# Access Compliance Report

## Public Rights-of-Way

### (Curb Ramps)

Intersection ID: 18050	Main Street: S_TRYON_ST	Cross Street: SOUTHAMPTON_RD	Location: NE
ADA ID: E0C7A4DA8D5C	Ramp Type: Directional1	Initial Pass/Fail: Fail	Overall Compliance: No
Severity Score: 1.25			
Codes/Mitigation Info/Possible Solution		Field Measurements/Component Compliance

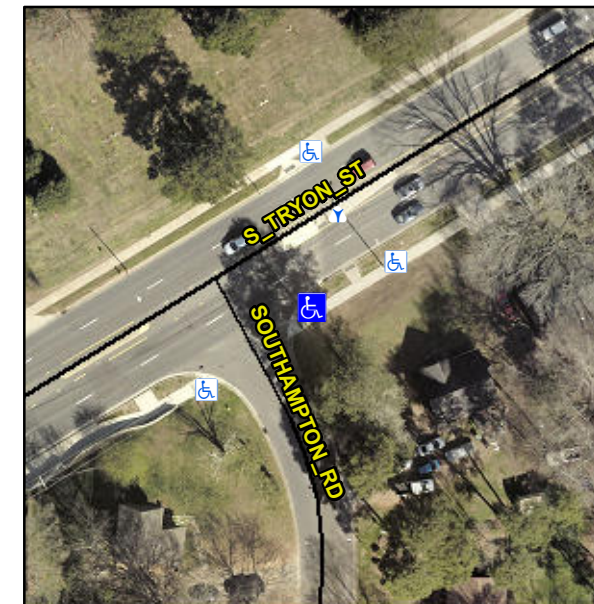
PROW/ADA:

**R304.5.3**

Compliance	Description	Data	Compliance	Description	Data
N/A	Ramp Length (in)	60.0	N/A	Grade Break?	N/A
Yes	Ramp Width (in)	72.0	N/A	Grade Break Slope (%)	0.0
Yes	Ramp Slope (%)	5.1	N/A	Grade Break XSlope (%)	0.0
No	Ramp XSlope (%)	4.0			
N/A	Flare Type LT	N/A	N/A	Flare Type RT	N/A
N/A	Flare Slope LT (%)	N/A	N/A	Flare Slope RT (%)	0.0
N/A	Flare Traversable LT?	N/A	N/A	Flare Traversable RT?	N/A
N/A	Landing Length (in)	0.0	N/A	DWS Provided?	N/A
N/A	Landing Width (in)	0.0	N/A	DWS Contrast?	N/A
N/A	Landing Slope (%)	0.0	N/A	DWS Length (in)	N/A
N/A	Landing X Slope (%)	0.0	N/A	DWS Full Width?	N/A
N/A	Landing Curb? (Y/N)	N/A	N/A	DWS Offset LT (in)	N/A
N/A	Shared Landing?	N/A	N/A	DWS Offset RT (in)	N/A
N/A	Gutter Ponding?	0.0	N/A	Gutter Slope (%)	N/A
N/A	Gutter Lip Ht (in)	0.0	N/A	Gutter X Slope (%)	N/A
N/A	Painted X Walk1?	No		Road Slope (%)	2.8
	X Walk 1 Direction	To SW		Road X Slope (%)	5.2
	X Walk 1 Width (in)	N/A		Clear Space?	N/A

**Remove & Replace Entire Ramp.**
